From: <George.Beck@exeloncorp.com>
To: <dja1@nrc.gov>, <rkm@nrc.gov>
Date: 04/05/2006 5:02:53 PM
Subject: FW: Audit Q & A (Question Numbers AMP-141, 210, 356)

NRC Information Request Form

<i>Item No</i>	<i>Date Received:</i>	<i>Source</i>
AMP-210	1/24/2006	AMP Audit
<i>Topic:</i>	<i>Status:</i>	Open
IWE

Item No
AMP-356

Sandbed Bay 11 Location A

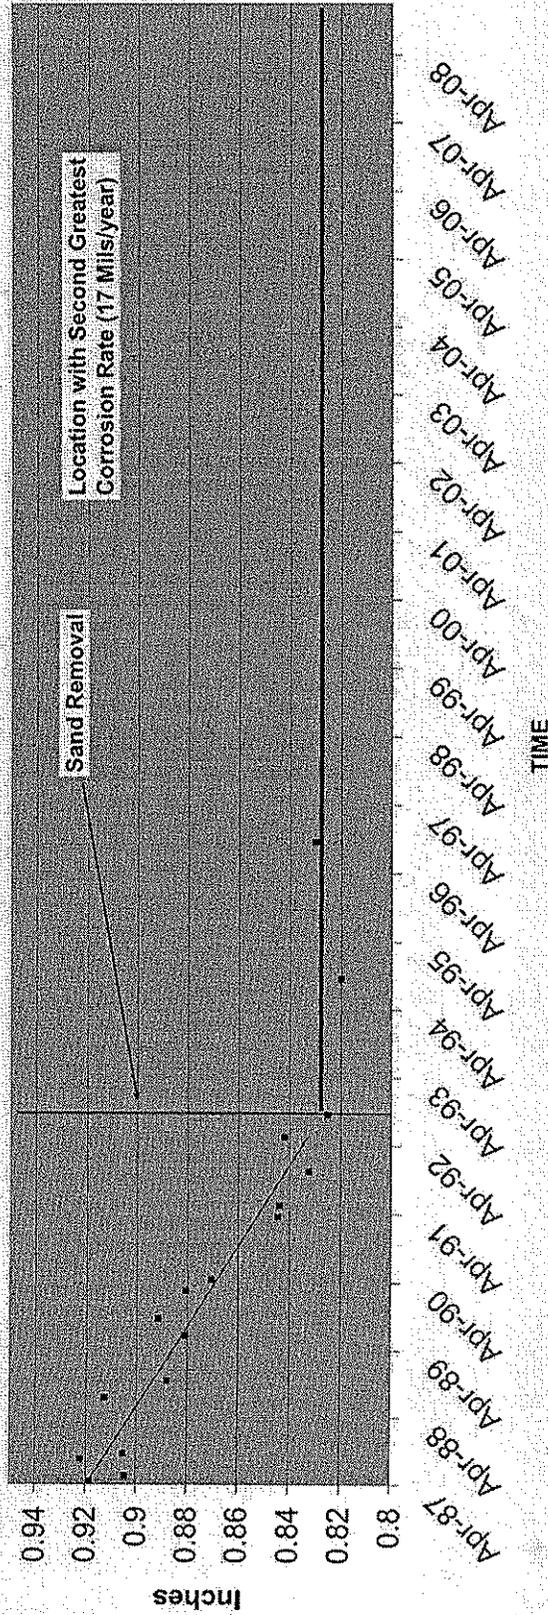
- (3) For each grid location, submit a graph of remaining thickness versus time, using the UT readings since the initiation of the program (both prior to and following removal of the sand and application of the external coating).

3. A graph representing the remaining thickness versus time using UT reading since the initiation of the program (both prior to and following removal of the sand and application of the external coating) for location 9D, 11A, 11C, 13A, 13D, 15D, 17A, 17D, 17/19, 19A, 19B, and 19C is included in the attached graph. Other locations (i.e. 1D, 3D, 5D, 7D, 9A, 13C, and 15A) are not included because wall thinning is not significant and the trend line will be essentially a straight line.
